RC3600 , 6000 , 7000 OPERATING GUIDES

FIELD CHANGE ORDER

EQUIPMENT AFFECTED
RC3600/6000/7000/8000
POW728
Master Power Supply Electronics

CONTROL MODULE
POW 728

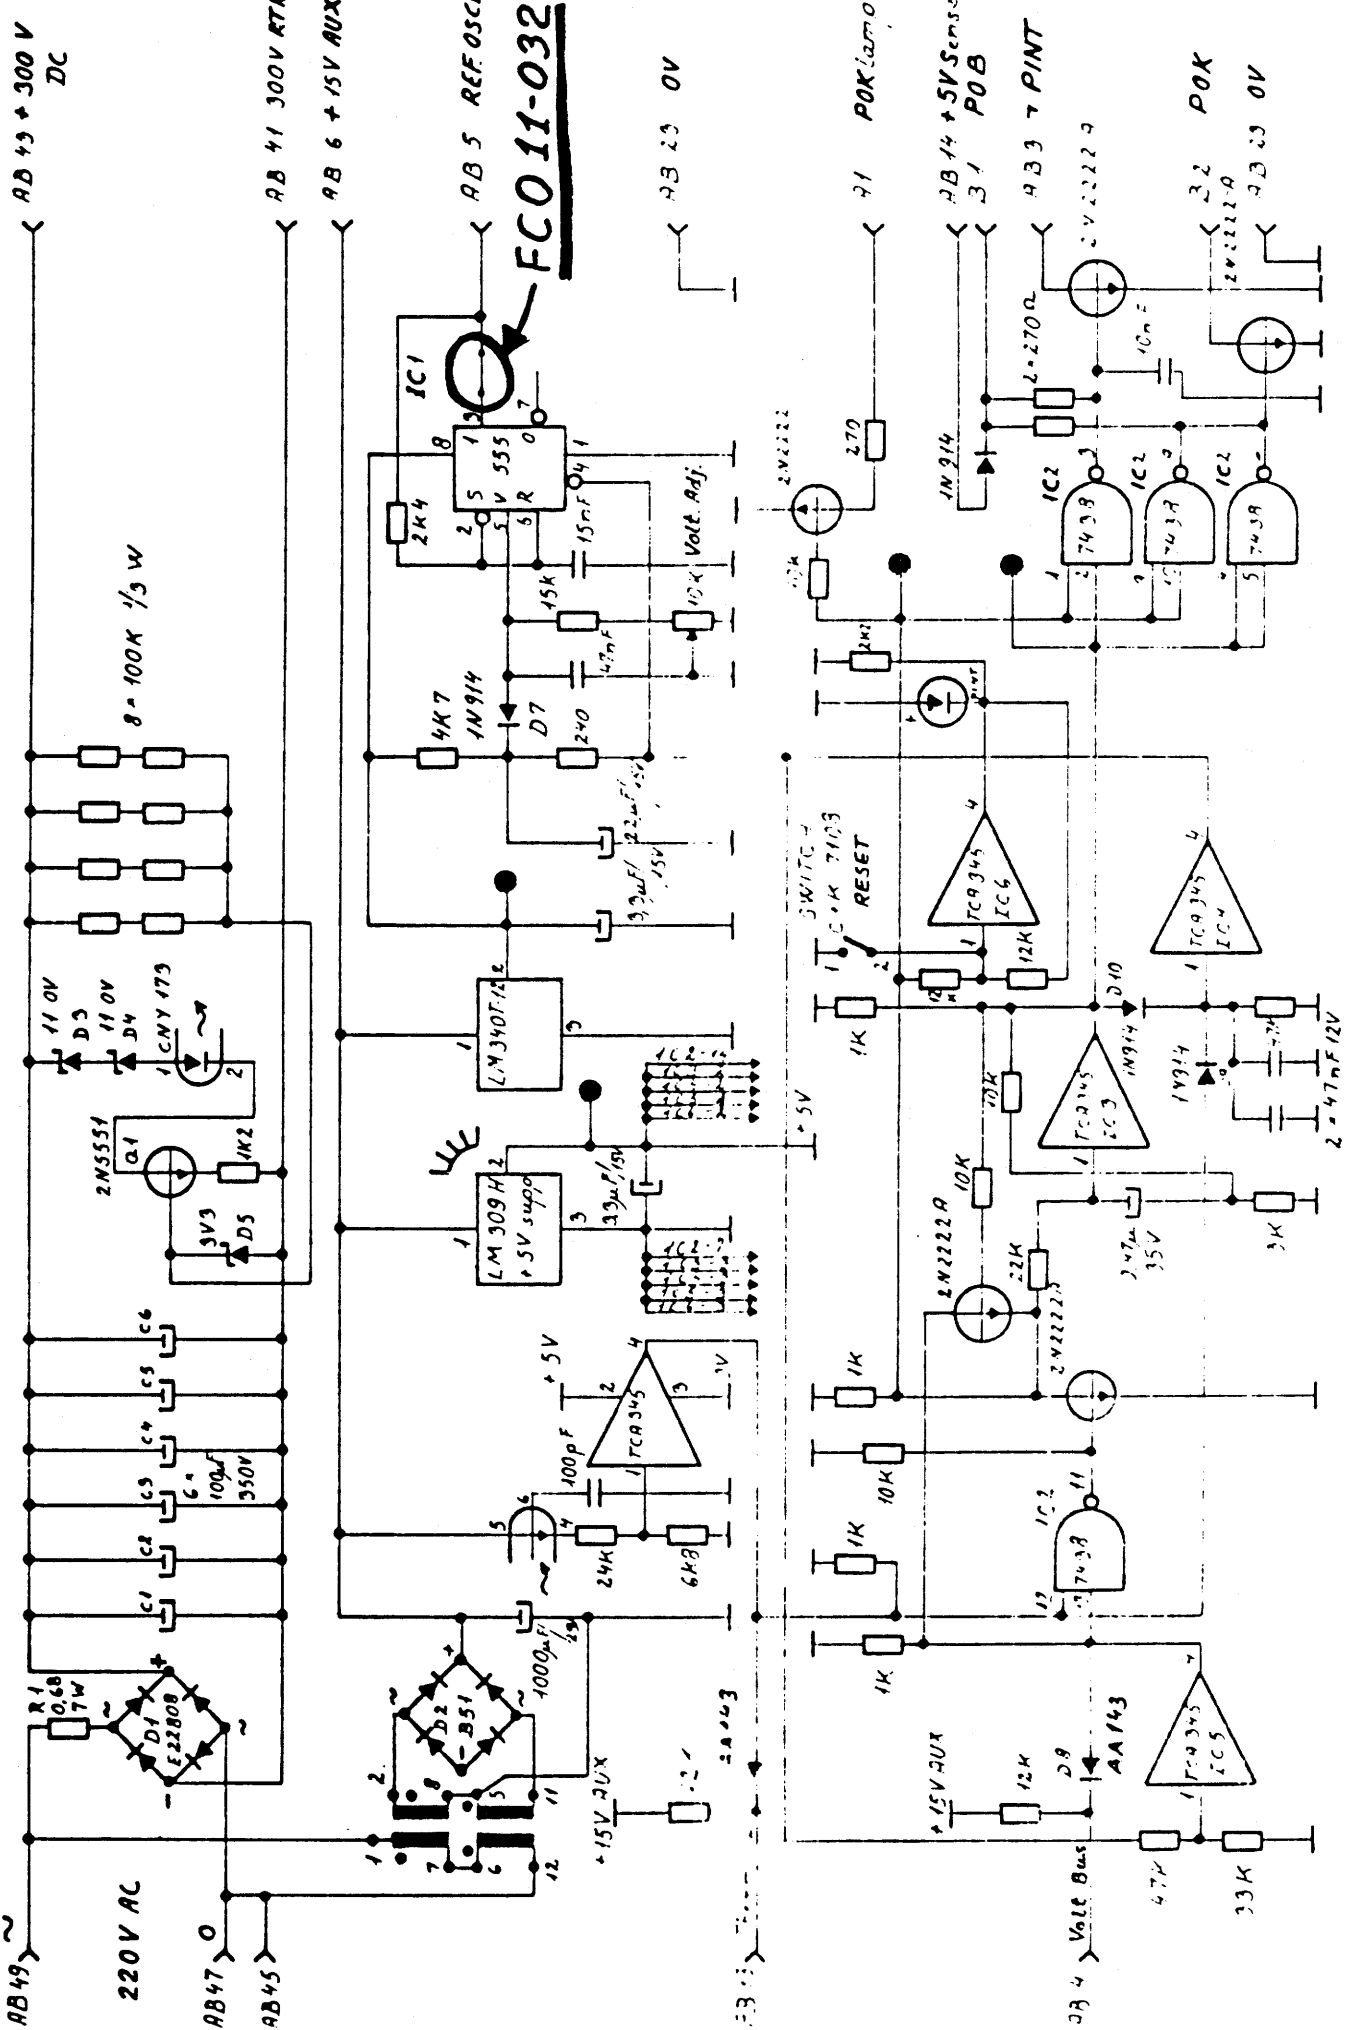
REASON FOR CHANGE
To eliminate undesired output voltage-dependency of the number of POW716 installed with the POW 728.

1. Replace a 100 ohms resistor by a jumper, as shown on page 2.
2. Install POW728 and remove all load (all boards).
3. Adjust the POW716 one by one to 5.00 Volts.
4. Reinstall all boards, power modules and the cover. Check that the voltage is within 4.9 to 5.1.
5. Code the FCO-label 11-032.

FCO 11-038

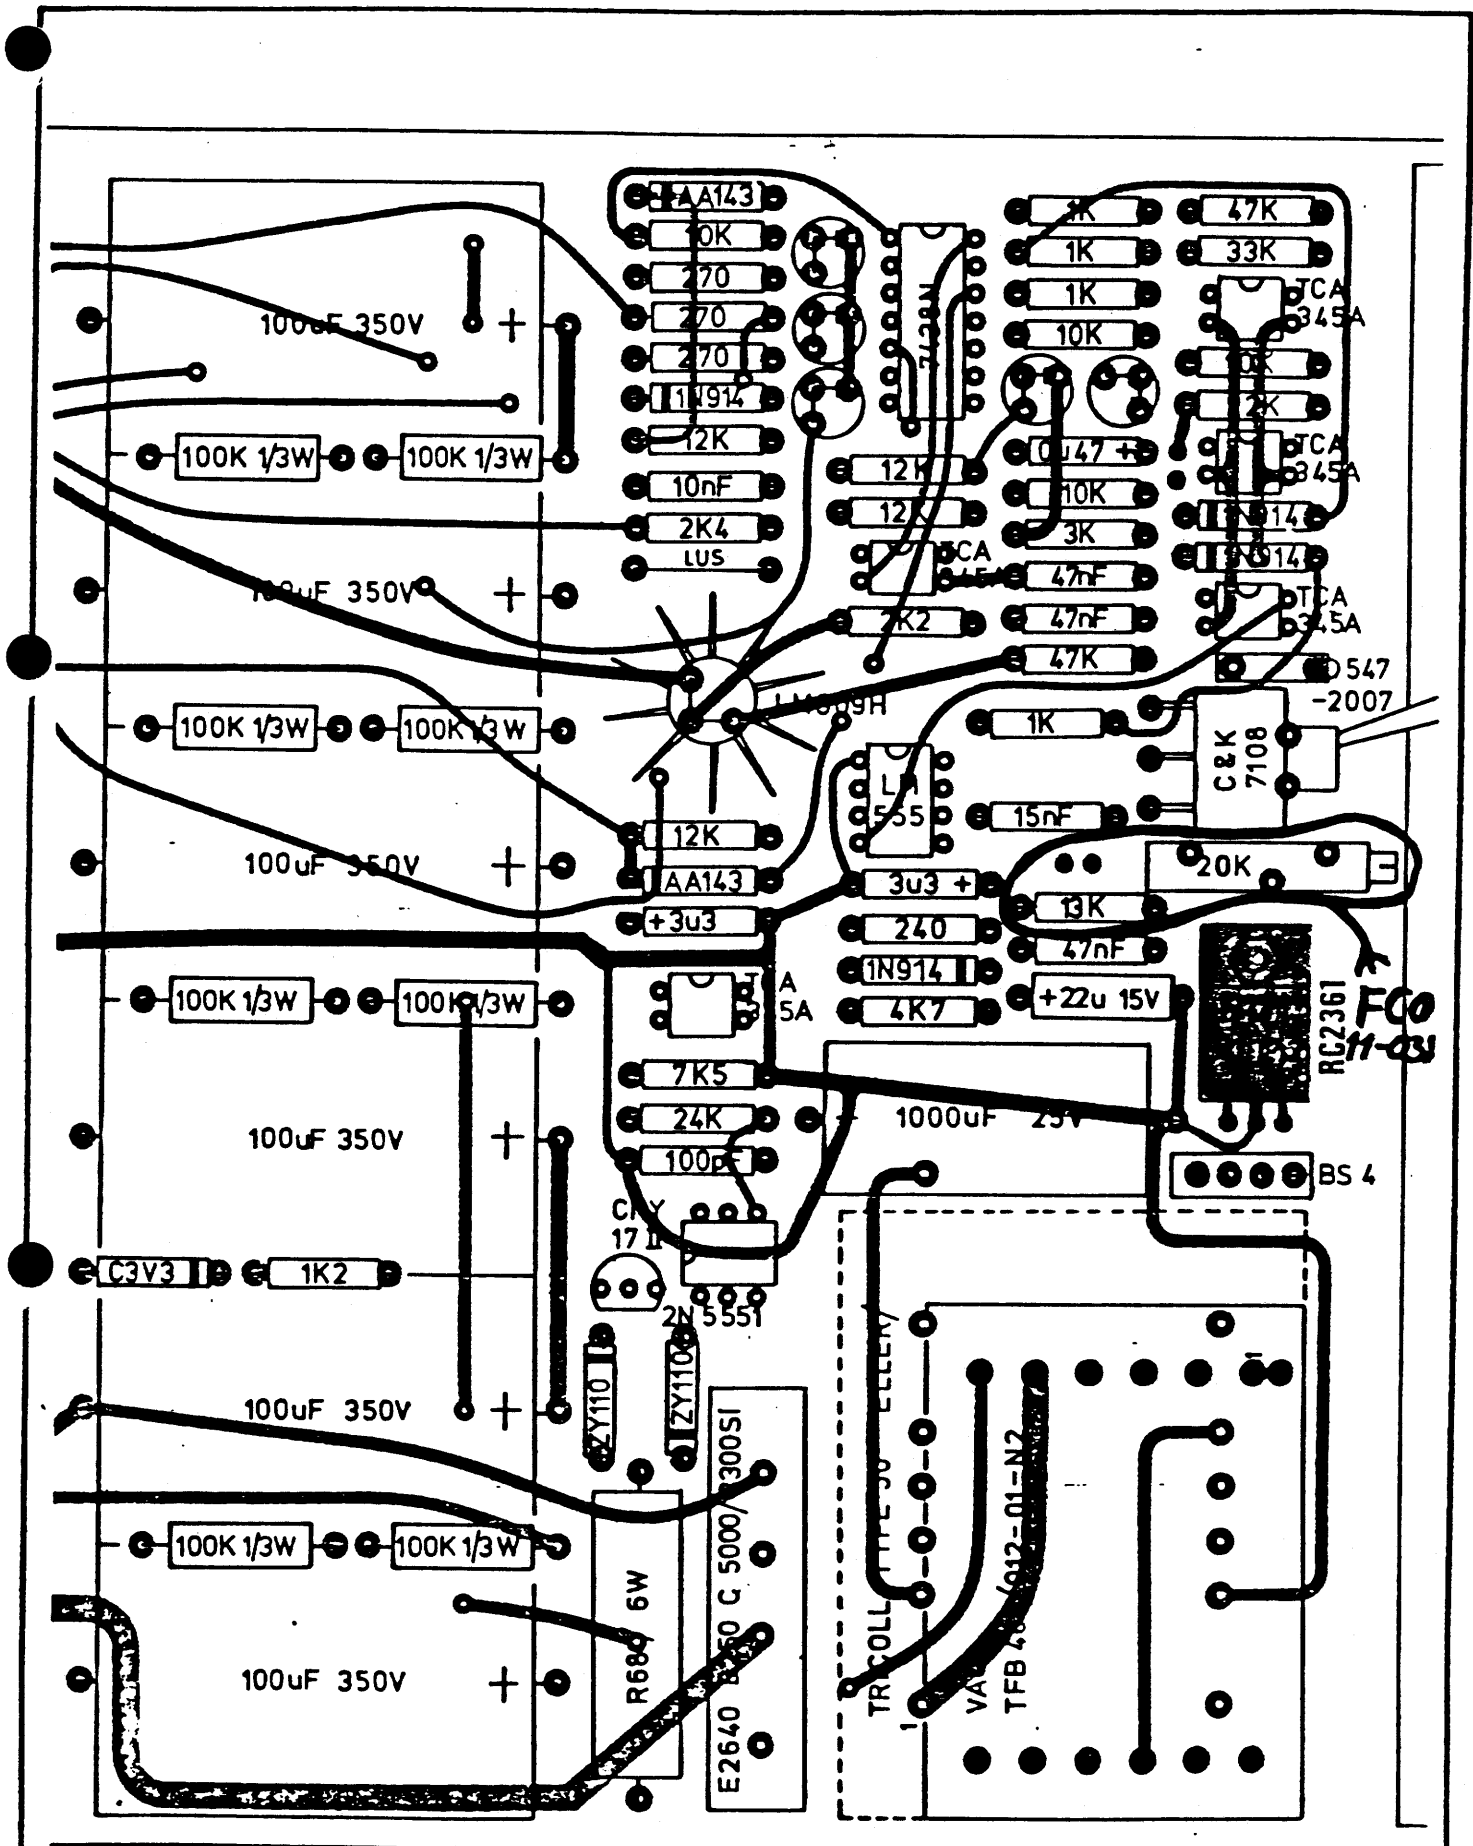
On some POW728's, the Voltage Adjustment Range does not cover the nominal +5% marginal of the Reference Clock (5.25 Volts DC).

1. Replace the 10 Kohms Voltage Adjustment Potentiometer with a 20 Kohms Potentiometer (see page 2).
2. Replace the 15 Kohms resistor, serial-connected to the Voltage Adjustment Potentiometer, with a 13 Kohms resistor (see page 2).
3. Code the FCO-label 11-038.

FCO 11-040

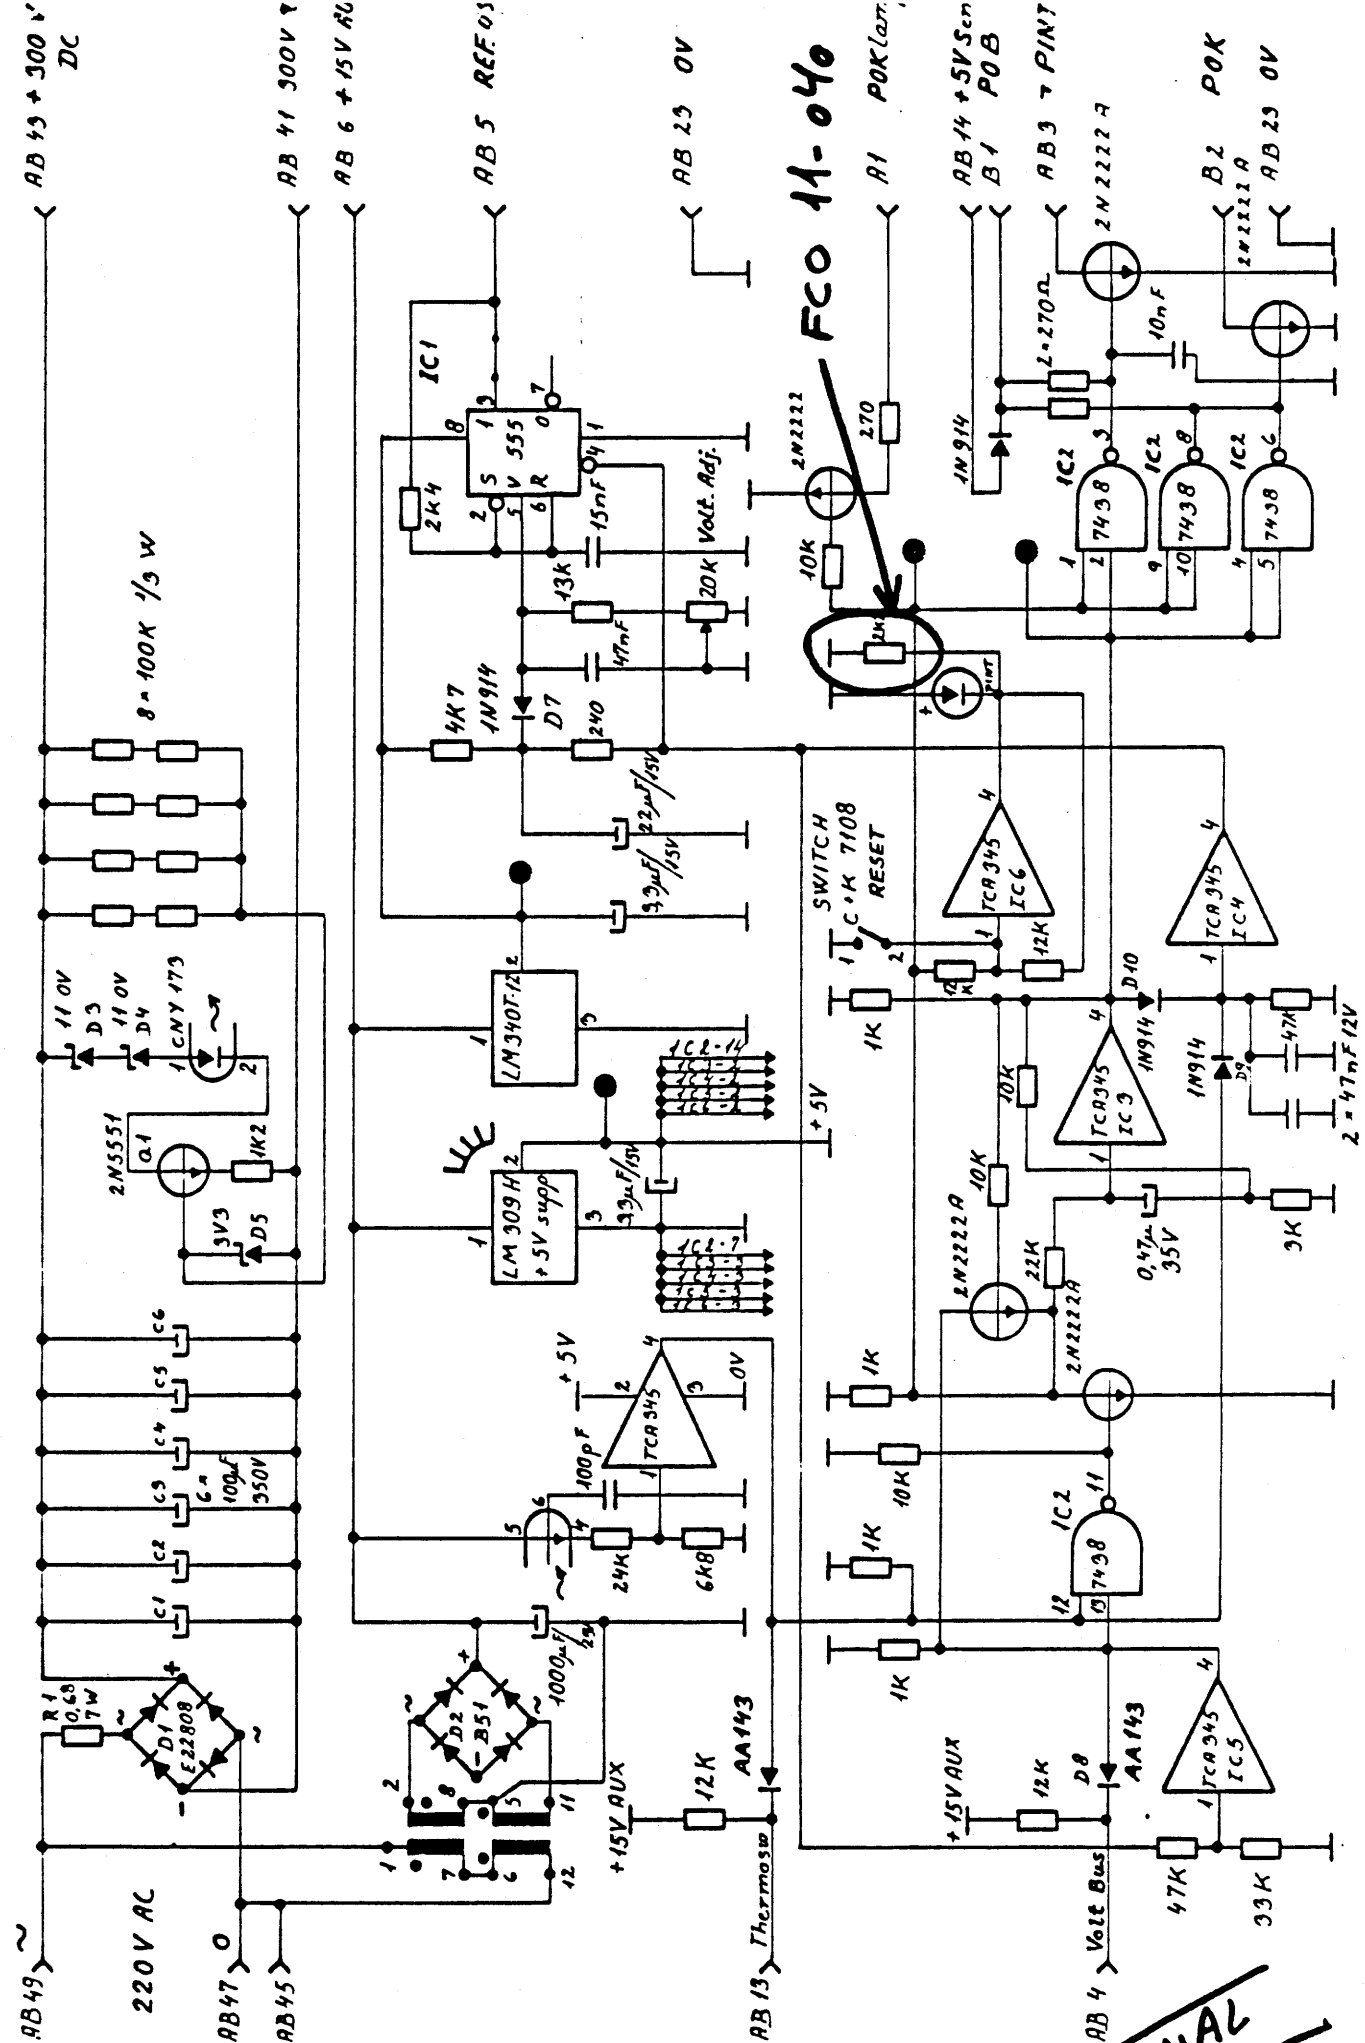
On some POW 728 it is possible to reset the Power Interrupt Indicator LED even if the >PINT signal is active.

Remove the 2K2 (2.2 Kohms) resistor parallel connected to the LED.

The failure has no effect on the electrical function of the module, but concerns only the diagnostic power interrupt indicator.

Remove wire (36 - 4) - (26 - 8) - (87 - 5)

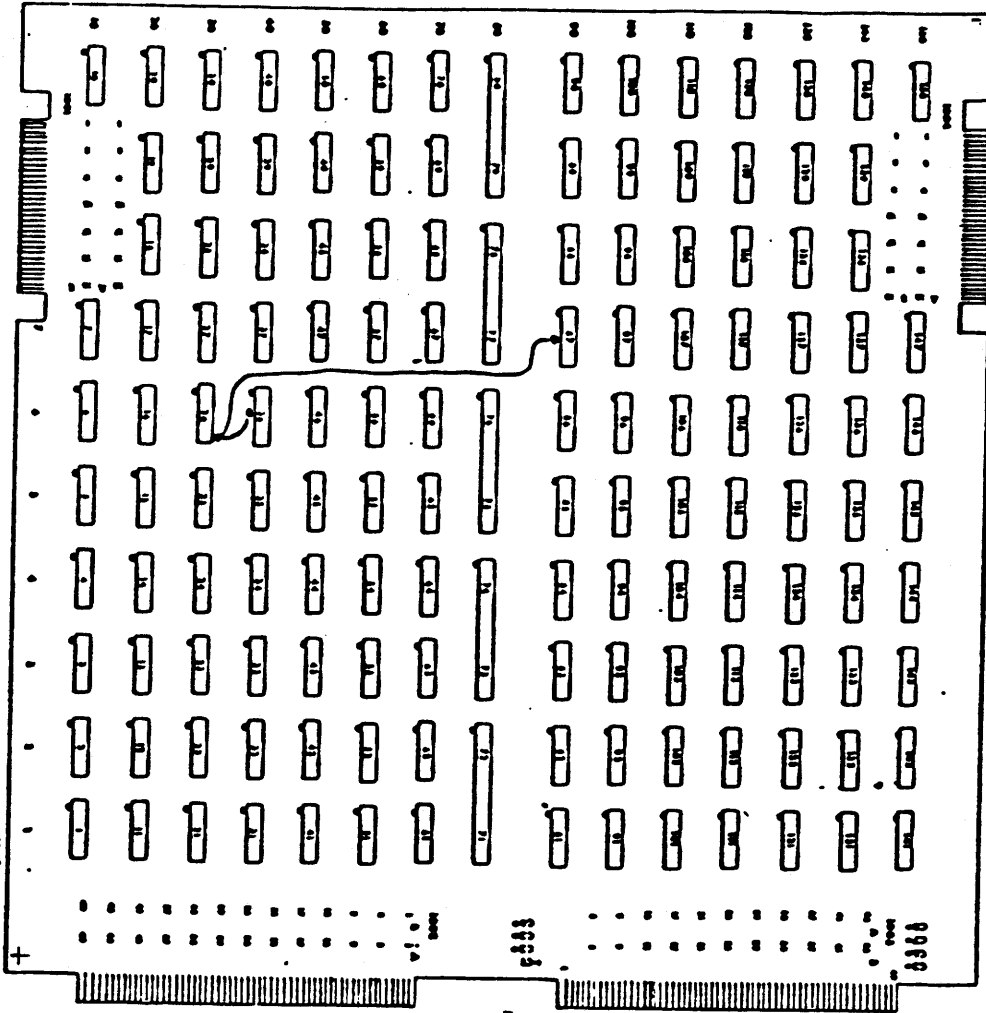
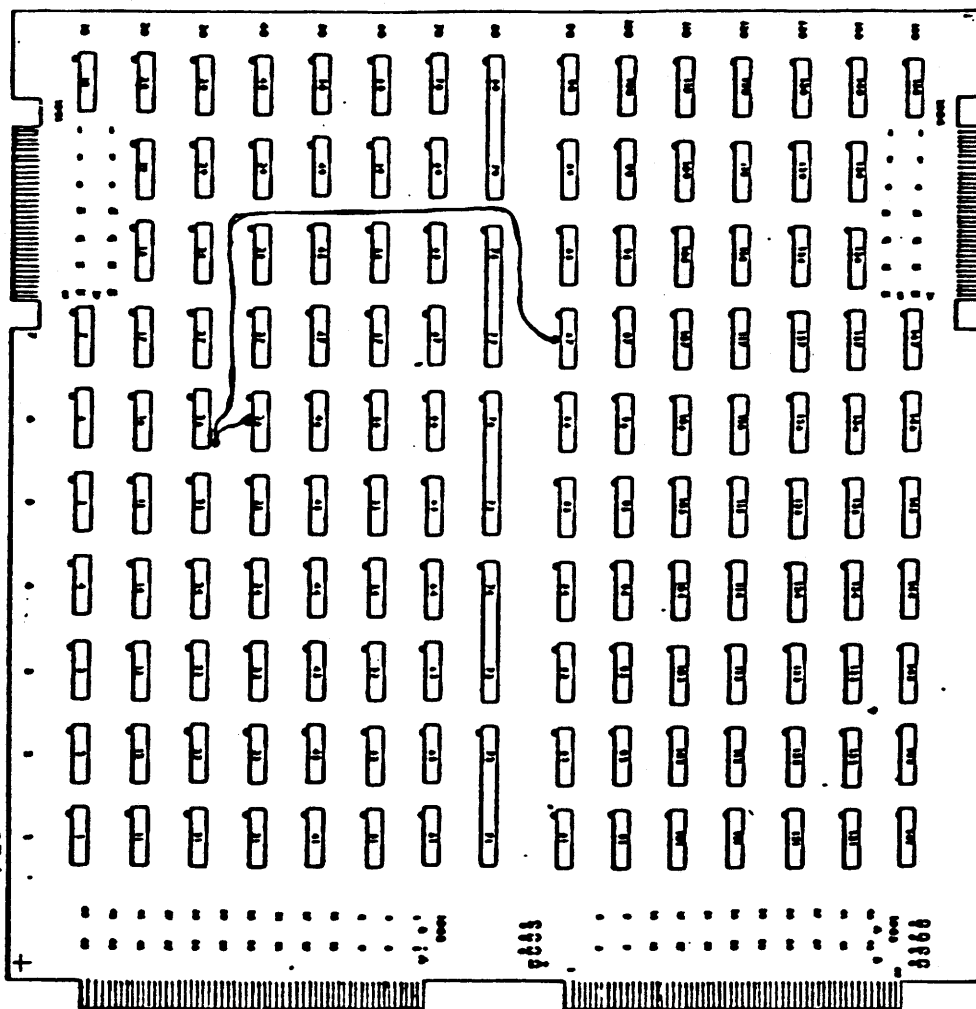
REASON FOR CHANGE
On the units with the serial numbers mentioned, the wire carrying the signal ENABLE STEP has been placed in noisy environments. If so, you might experience that the CPU cannot run except with the Technicians Panel (TCP) connected and enabled.

DESCRIPTION OF CHANGE
The solution to the problem is to relocate the wire (36 - 4) - (26 - 8) - (87 - 5).
1. Remove the wire (36 - 4) - (26 - 8) - (87 - 5). (see page 2)
2. Insert the wire (36 - 4) - (26 - 8) - (87 - 5) as shown on page 3.
3. Code the FCO-label 11-049.

Insert wire (36 - 4) - (26 - 8) - (87 - 5)

ATTENTION : The drawn path MUST be followed.
